**From:** karen Buckingham  
**Sent:** 18/02/2022 11:37:40 AM  
**To:** Council Northernbeaches Mailbox  
**Cc:** andre karemacher  
**Subject:** FAO: Megan Surtees - Objection letter re: DA2021/2146 - 35 Kangaroo Street, Manly  
**Attachments:** Objection letter - DA20212146 - 35 Kangaroo St Manly.pdf;

**Submission with regard to Development Application DA2021/2146  
Alterations and Additions to a dwelling house –  
35 Kangaroo Street, Manly, NSW**

**Figure 2 – DA230/2011 – Extract from Architectural Plans – previously proposed balcony extension**

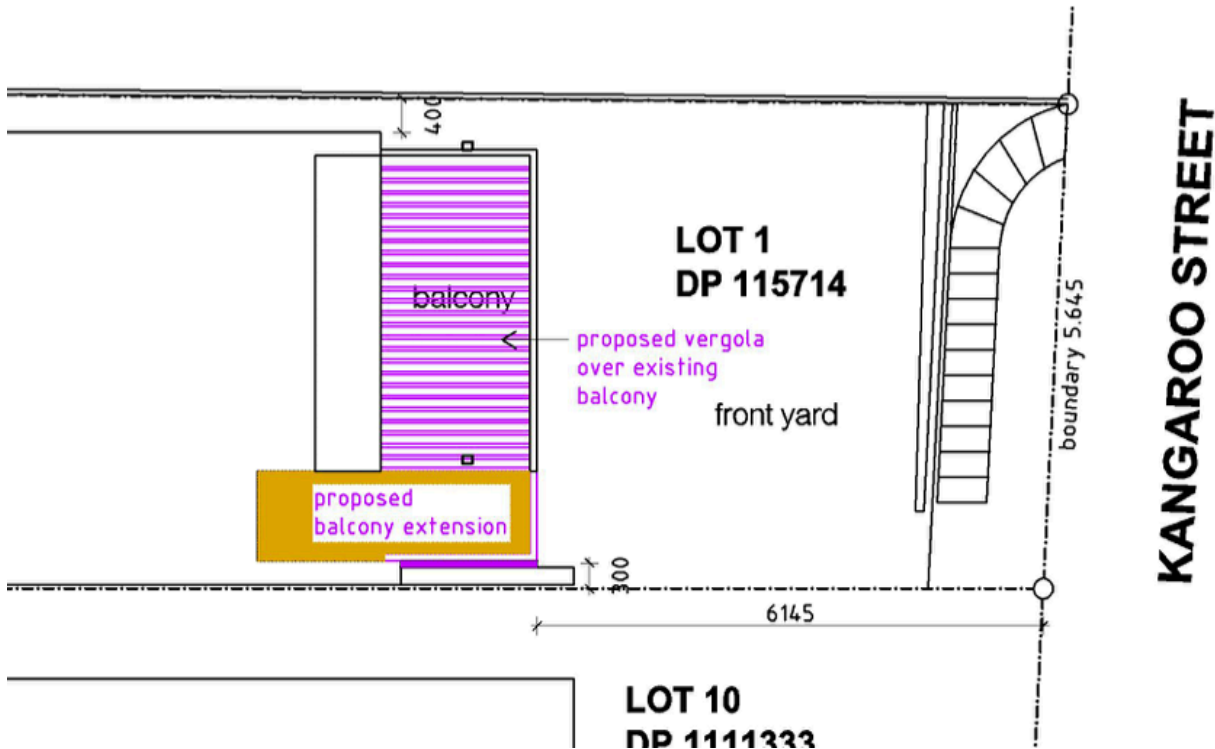
**Comment:** The above DA sought to extend the front/eastern elevation balcony, 300mm off the southern boundary, as shown in figure 2 and 4.

DA230/2011 was approved subject to conditions, including a condition to retain a 1 metre side setback to the southern boundary as opposed to the 300mm proposed. The extracted condition and supporting assessment report extract is shown in figure 3.

**Figure 4 – Comparison between the proposed extension to the existing balcony under the subject DA and the proposed balcony extension conditioned to be removed and set back 1 metre off the northern side boundary under DA230/2011.**

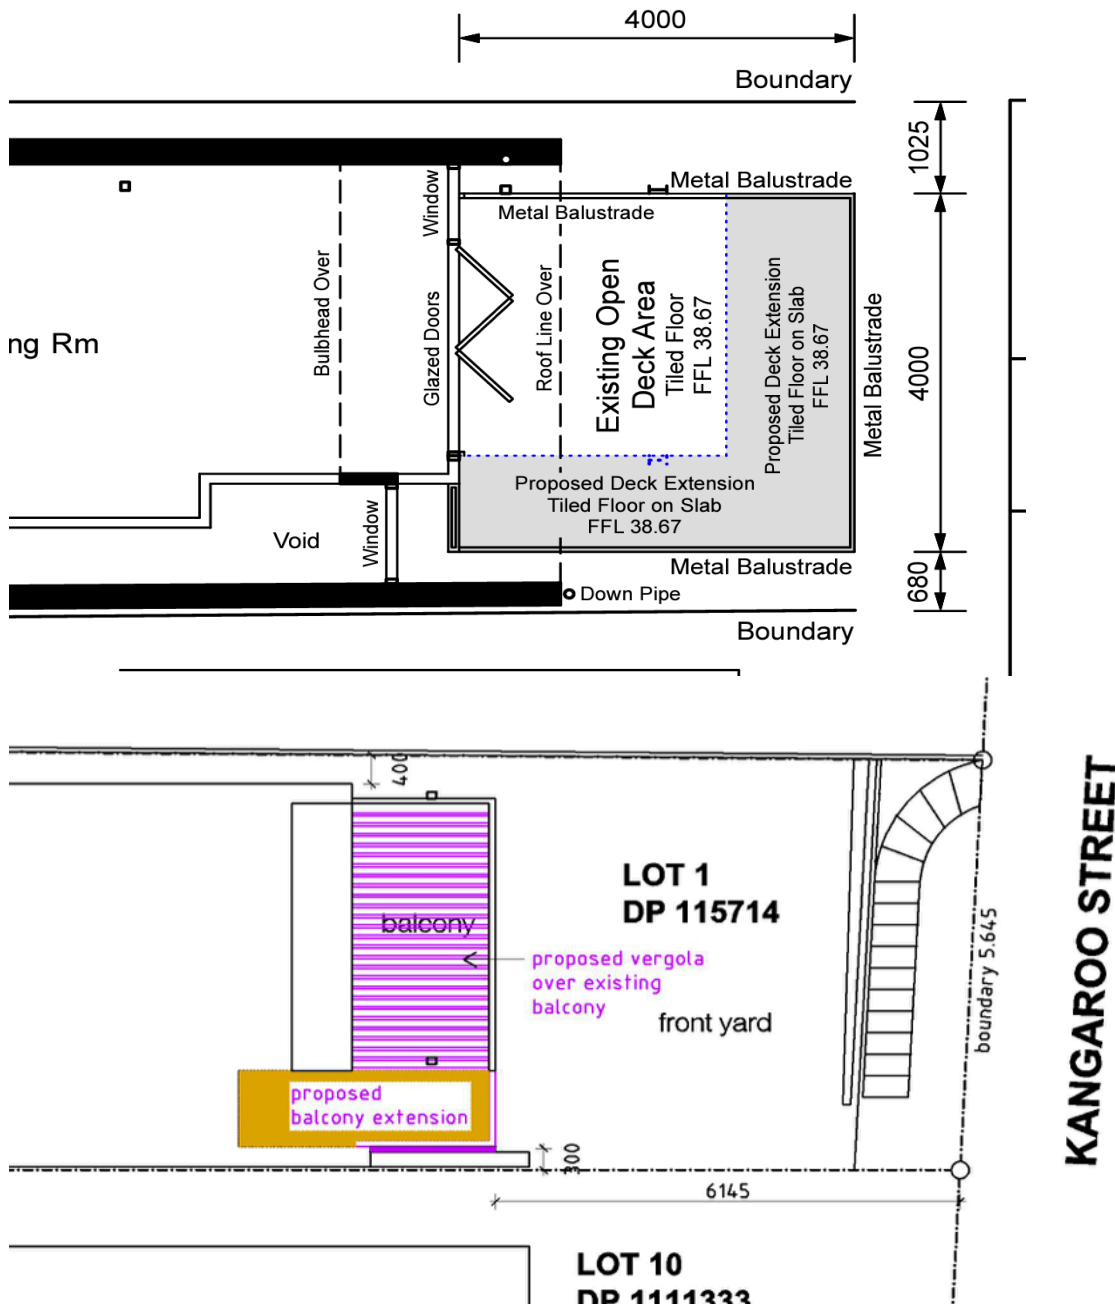
A comparison of the 300mm setback proposed and refused (via condition) under DA230/2011 with the proposed setback of 680mm under the subject DA is shown in figure 4. It is requested that Council check the scaled dimensions proposed as the setbacks of 300mm and 680mm as shown in figure 4, appear to look the same. Notwithstanding the fact, that 680mm is significantly under the 1 metre required side setback established under DA230/2011.

**Figure 6 – Extract from Architectural plans showing proposed extended balcony**

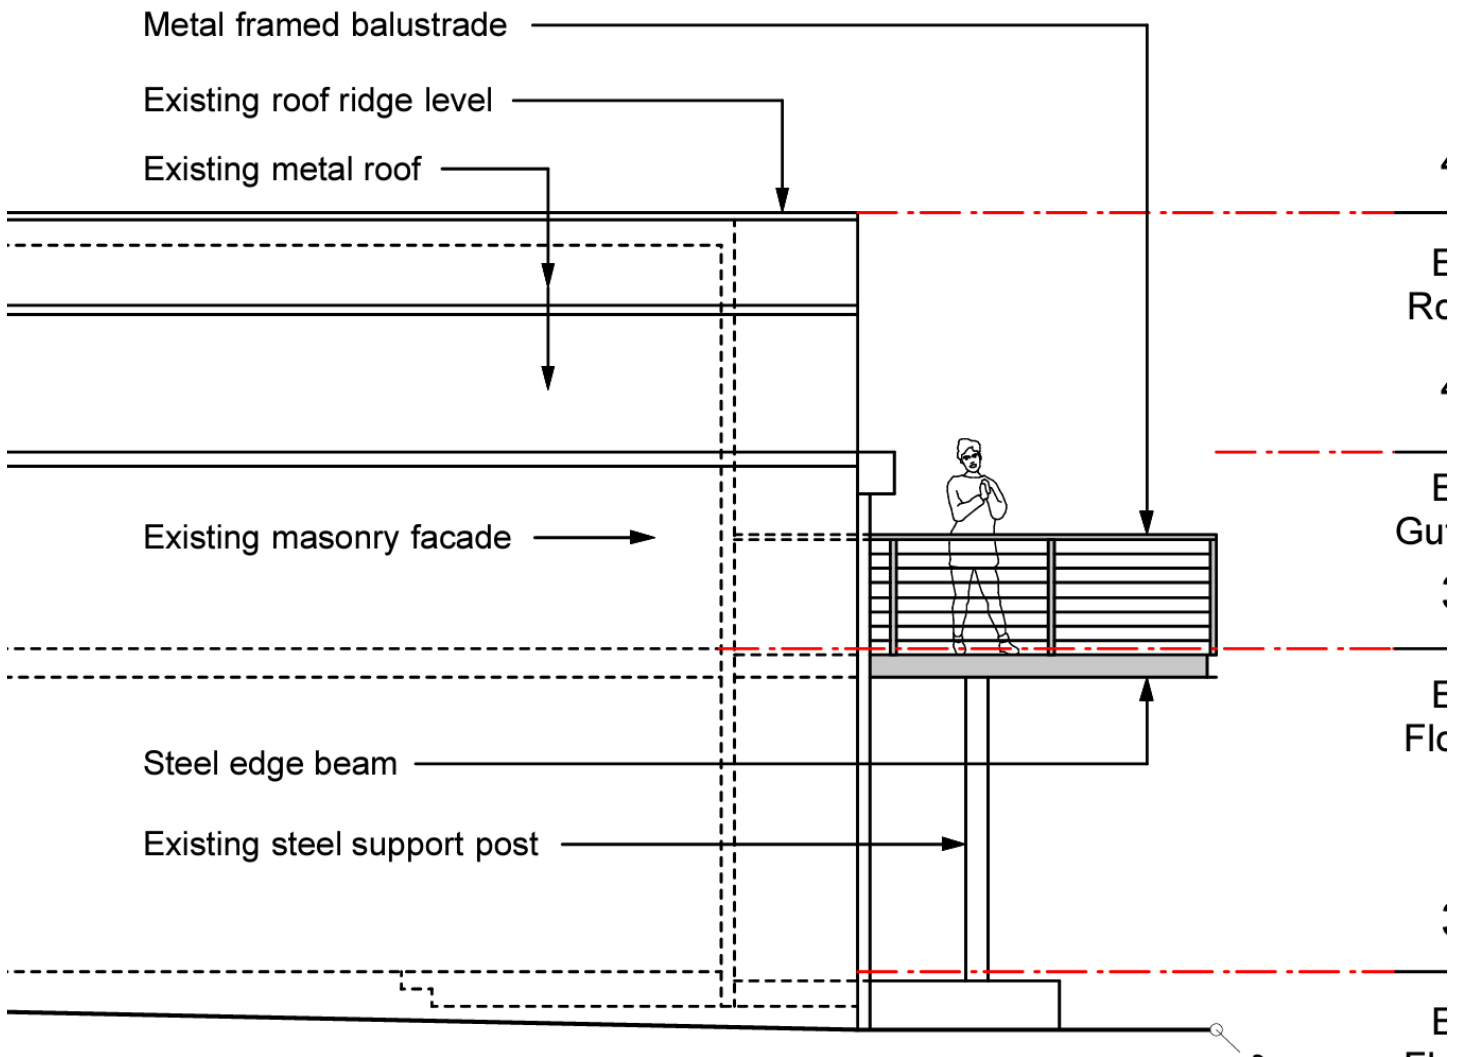
**Comment:** The proposed extended balcony to the front/eastern elevation is proposed to be an elevated structure on extended columns that, by virtue of the extended area, would appear as a large, incongruous structure when viewed from the streetscape and dominate the adjoining property at no. 33 Kangaroo Street. It is acknowledged that the columns to support the existing balcony are in situ, as existing. However, it is the extended bulk, scale and set backs of the proposed (extended) balcony which would give rise to the harm.

Further to this, the proposed extended balcony will significantly encroach into the street front setback, as discussed under DCP Control 4.1.4.1, by 1.3 metres resulting in a reduced setback of only 4.78 metres as opposed to the 6 metre general requirements. The encroachment in to the front setback would be contrary to the established front set back in the immediate vicinity of the site, as shown in photo 2.
